**AGENDA
CITY OF BELTON
PLANNING COMMISSION MEETING
MONDAY, NOVEMBER 8, 2021 - 5:30 P.M.
CITY HALL ANNEX, 520 MAIN STREET
www.belton.org/watch**

LOT SPLIT
15812 HARRIS AVENUE
BELTON PLANNING COMMISSION
MONDAY, NOVEMBER 8, 2021 – 5:30 P.M.
CITY HALL ANNEX BUILDING – 520 MAIN STREET

**FINAL DEVELOPMENT PLAN
TAKE 5 OIL CHANGE & 151 COFFEE
BELTON PLANNING COMMISSION
MONDAY, NOVEMBER 8, 2021 – 5:30 P.M.
CITY HALL ANNEX BUILDING – 520 MAIN STREET**

DRAWN	JPH
CHECKED	RCG
ISSUED DATE	9-29-21
ISSUED FOR	FINAL DEVELOPMENT PLAN
PROJECT NO.	21-120
FILE	21-120 SITE
SHEET	C-1

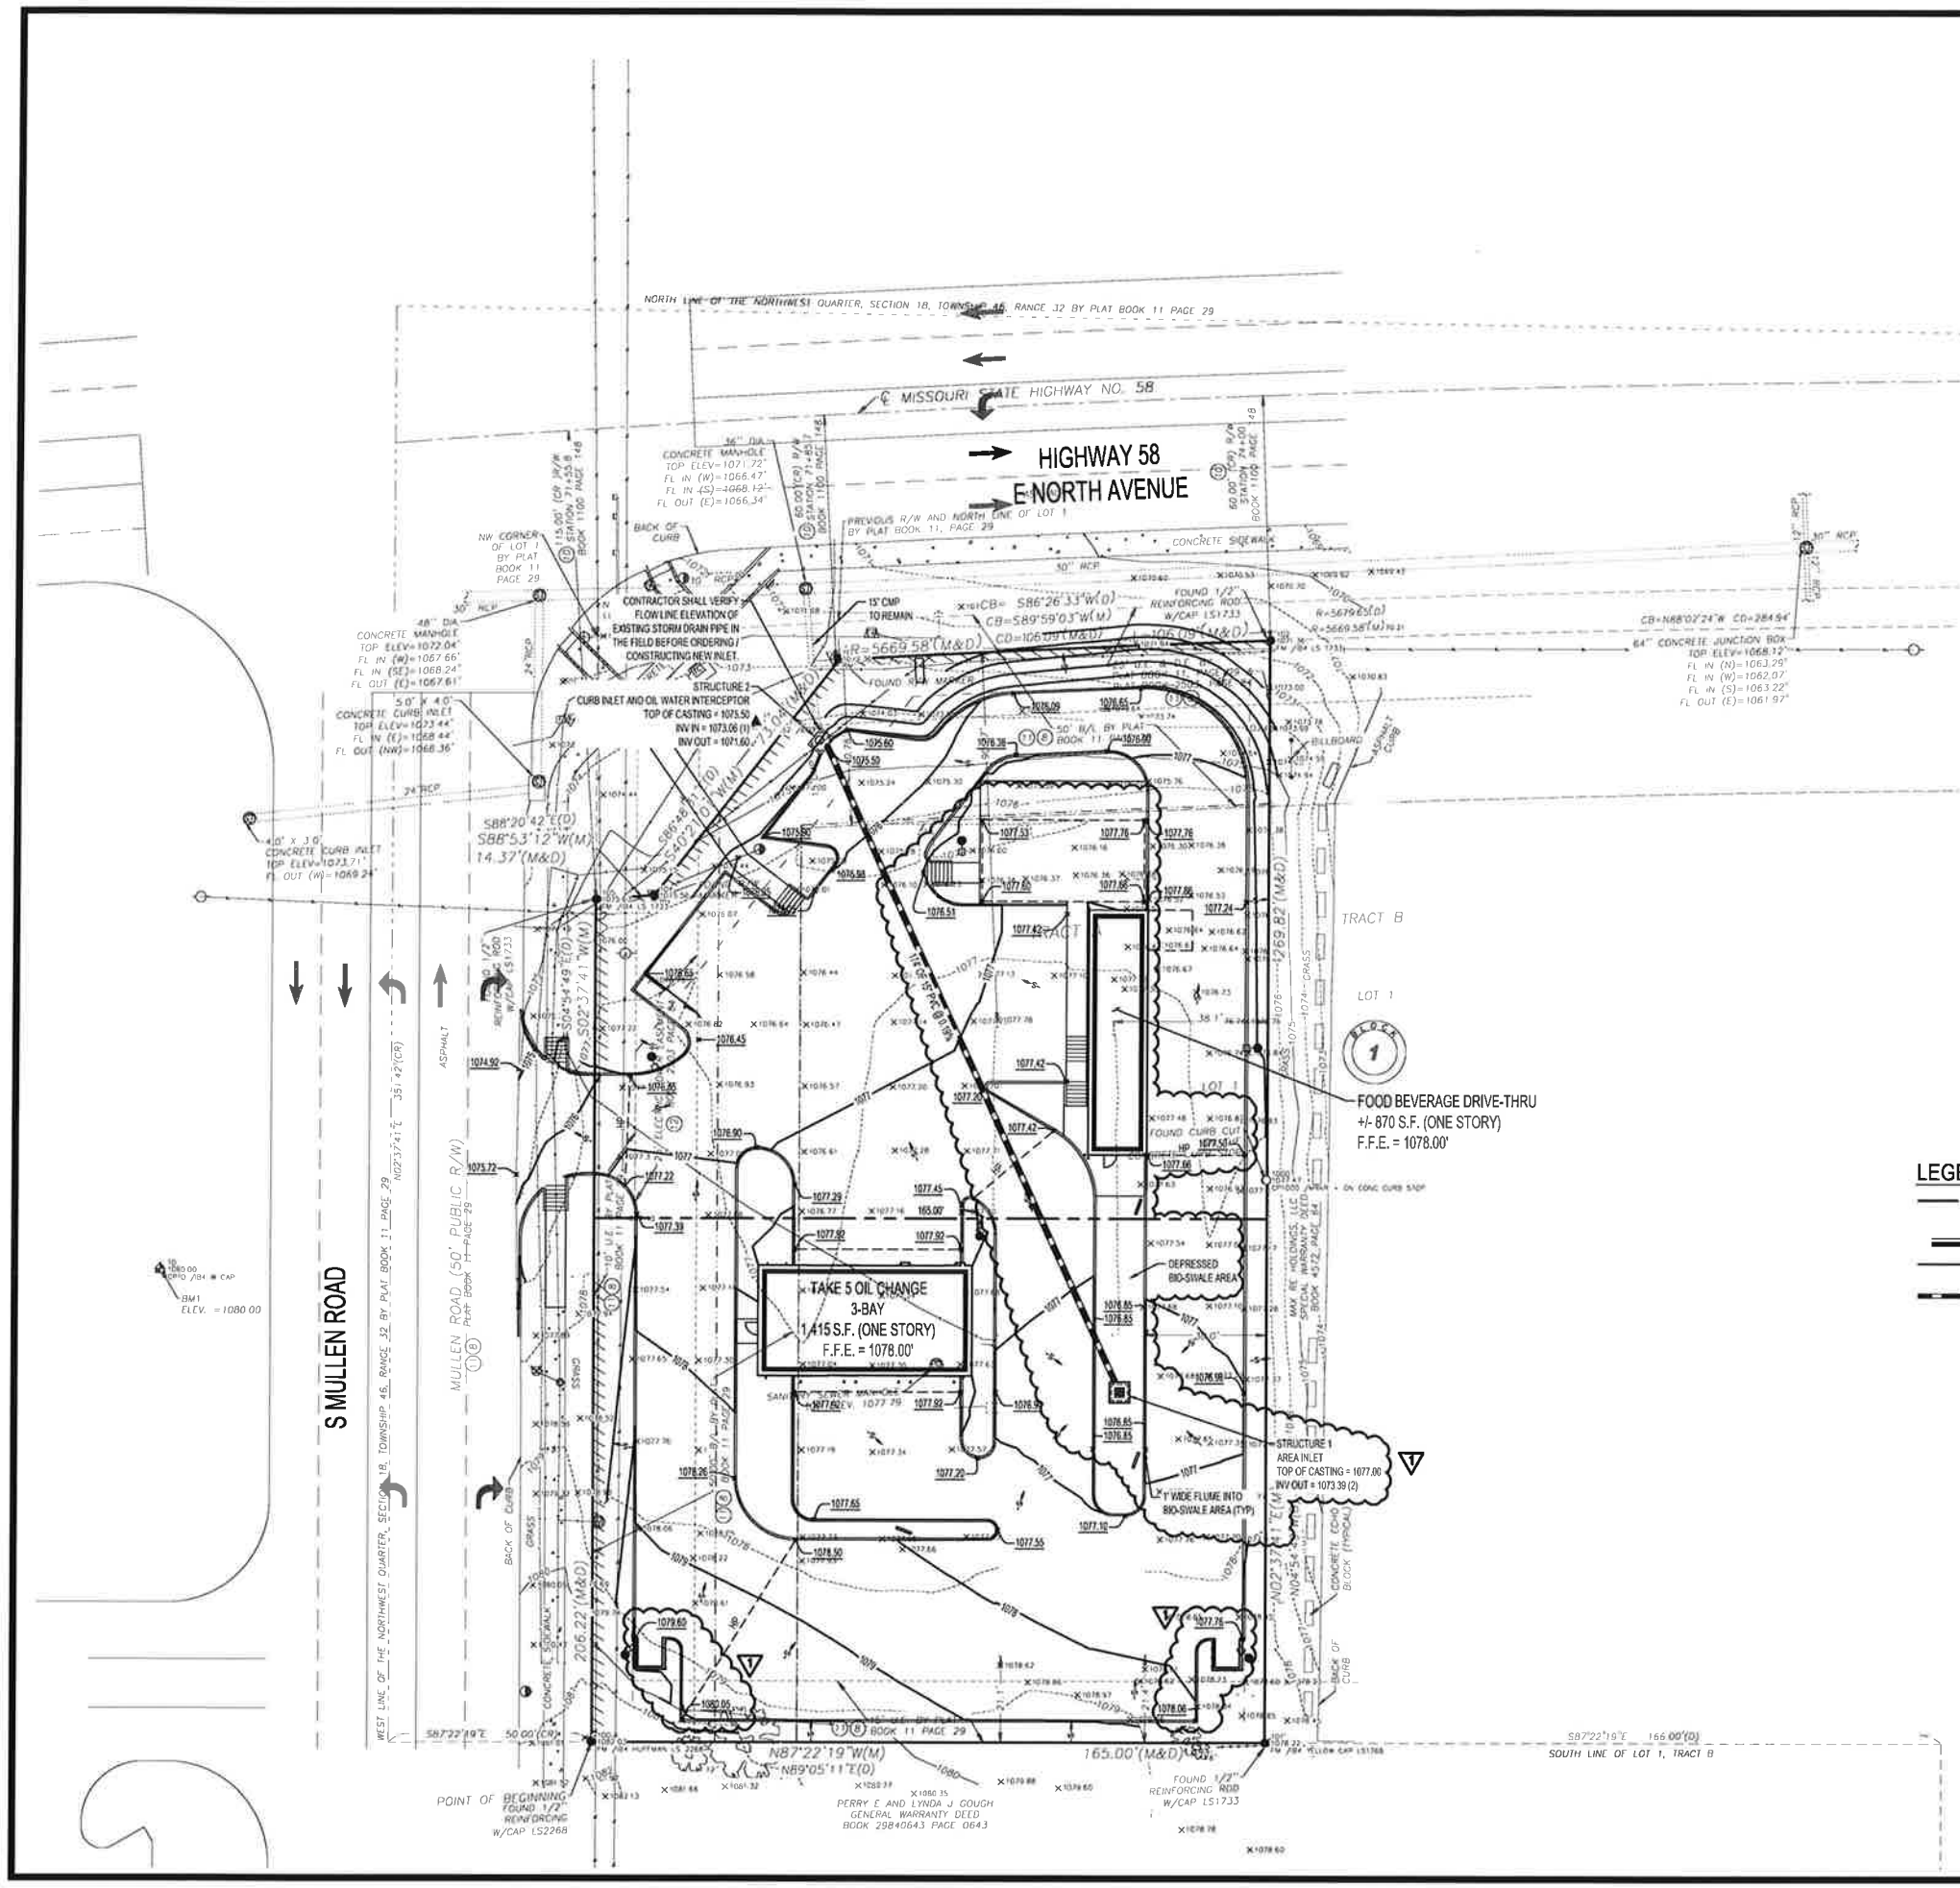
The subject site is a .96-acre site located at the southeast corner of S. Mullen Road and E. North Avenue. There is one new 24-foot driveway entrance on Mullen Road that provides access to both users. This drive is at approximately the same location as the drive for the existing carwash, but it will be redesigned. There is no access proposed to East North Avenue.

Parking/vehicle stacking: The combined parking requirement for both uses is 22 spaces. This is based on the number of seats and customer service area of *151 Coffee*, and the number of service bays for *Take 5 Oil Change*.

Four vehicle stacking spaces behind the menu board are required for *151 Coffee*. There are 9 spaces in the customer queue on the east side of the building.

Front yard-30-foot required setback. The front setback along E. North Avenue is 40 feet to the edge of the covered patio. The front setback along Mullen Road is 40 feet.

A land-use analysis and site data table is found on Sheet C-1, for overall project specifics.

1. The Final Development Plan for *Take 5 Oil Change* and *151 Coffee* is hereby approved, as shown on plans prepared by High Tide Consultants, LLC. dated 9/29/2021, subject to additional conditions.
2. The trash enclosure shall be constructed with masonry materials to match the buildings, with screening and landscaping.
3. The site photometric plan shall be revised to indicate zero-foot candles at the property line and meet all requirements of Section 28-7.
4. Please provide a 5' utility/ROW easement along the south property line.
